Subject: Starwood-Midway Additional Project Information
Site Plan Review No. 7584

PRELIMINARY PLAN

NO: SM-100-BP001

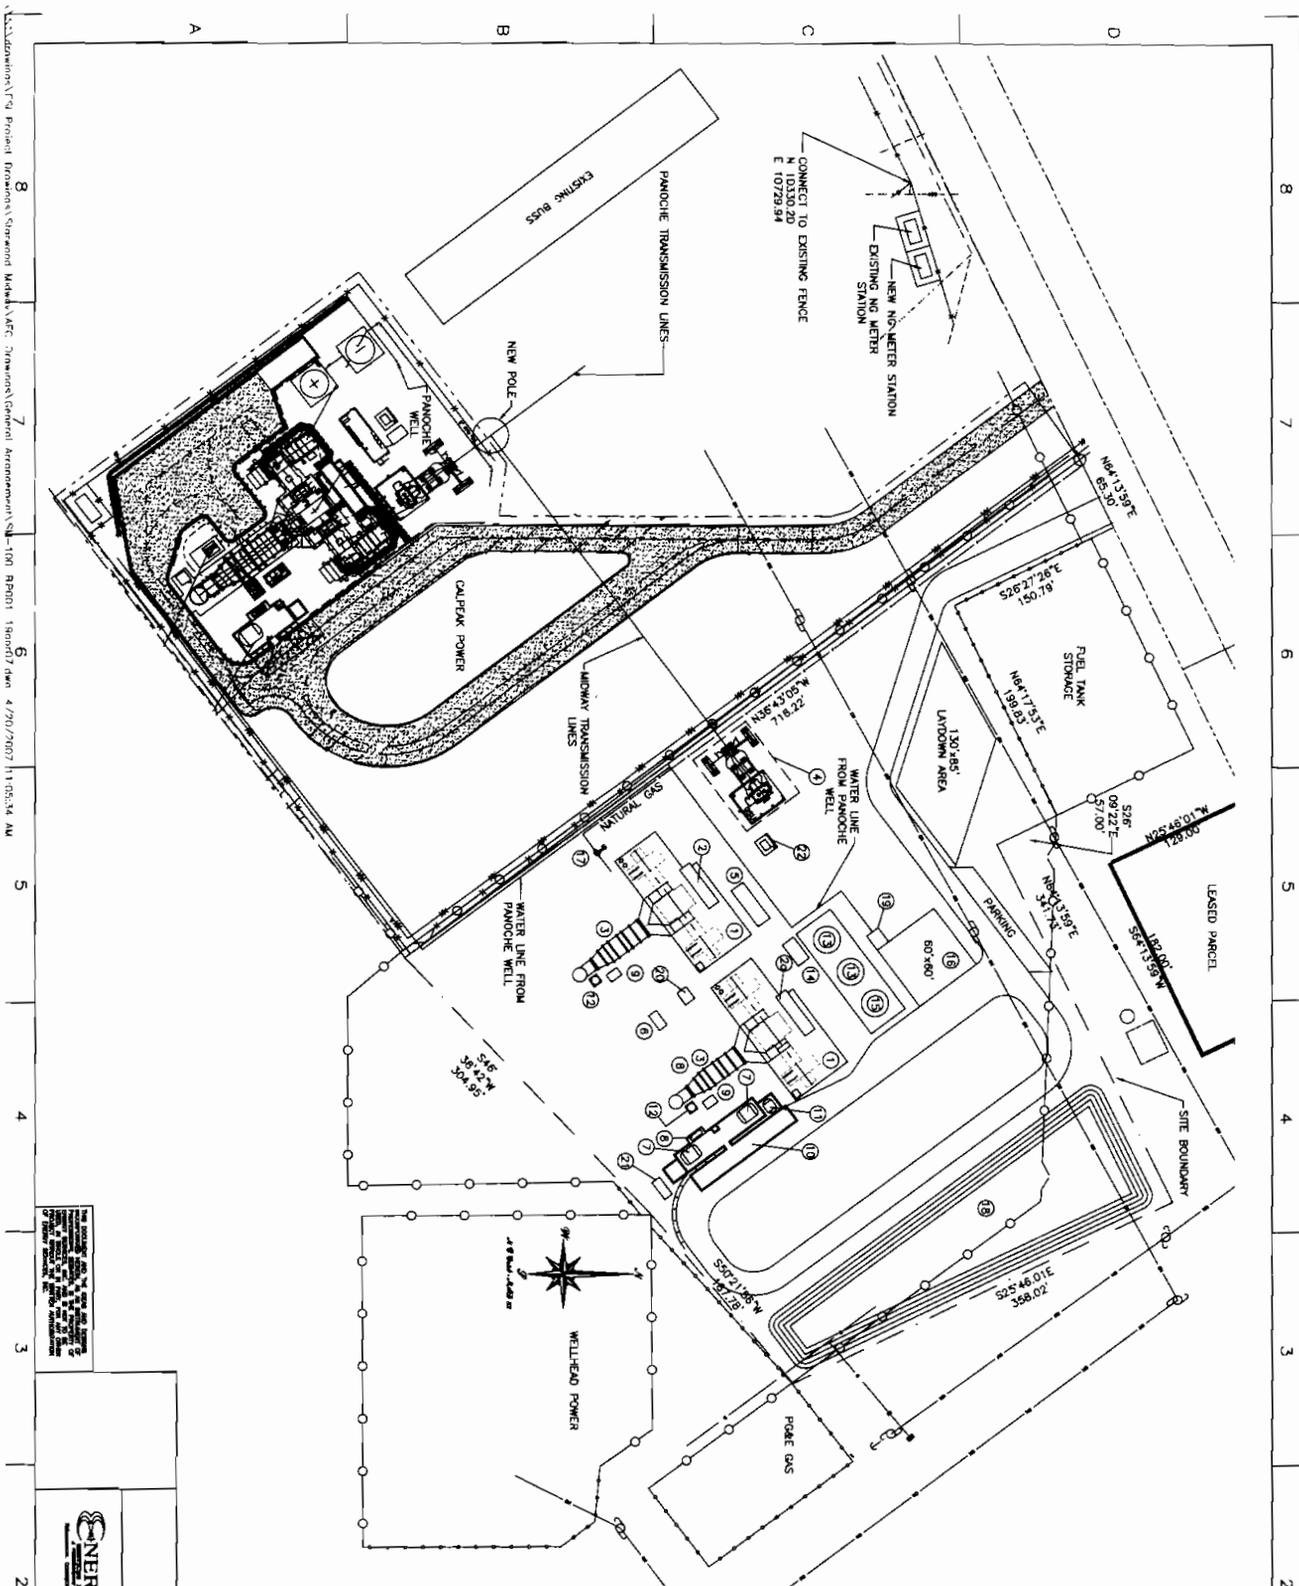
1. Addition of an Oily Water Separator (OWS) on-site to collect oily waste from equipment areas (like transformer containment areas). Effluent (water) will be directed to the on-site evaporation pond. Oils collected will be pumped to a disposal truck and hauled off-site.

2. Relocation of "Waste Water System Above-Ground Storage Tank" (item 21 on previous Preliminary Plan submitted with the Midway AFC). This tank has been renamed as "GT Drain Tank" and relocated/renumbered to item 11 on the Revised Preliminary Plan. The "Wash Down Drain Tank Area" has been removed.

3. Rename "Waste Water System Collection Sump" (item 20 on Revised Preliminary Plan) to "GT Drain Collection Sump". This Gas Turbine Drain Collection Sump along with the OWS (item 21) will collect waste from the GT areas. The OWS will also collect waste from containment areas (transformers) and equipment washdown areas (such as the air compressor/dryer skid).

4. The Auxiliary Transformer has been added to the Revised Preliminary Plan as item 22.
5. Shift the DI Trailer pad (item 16 on Revised Preliminary Plan) to connect to the proposed internal roadway/vehicle turnaround area.

6. As the site is in a floodplain, the top of foundations will be raised 3 feet above existing grade to comply with Fresno County regulations and avoid impacts related to the 100-year flood zone. This modification is in response to Fresno County Site Plan Review (March 7, 2007).

7. The proposed on-site evaporation pond will provide stormwater retention for the Project. This modification is in response to Fresno County Site Plan Review (March 7, 2007).
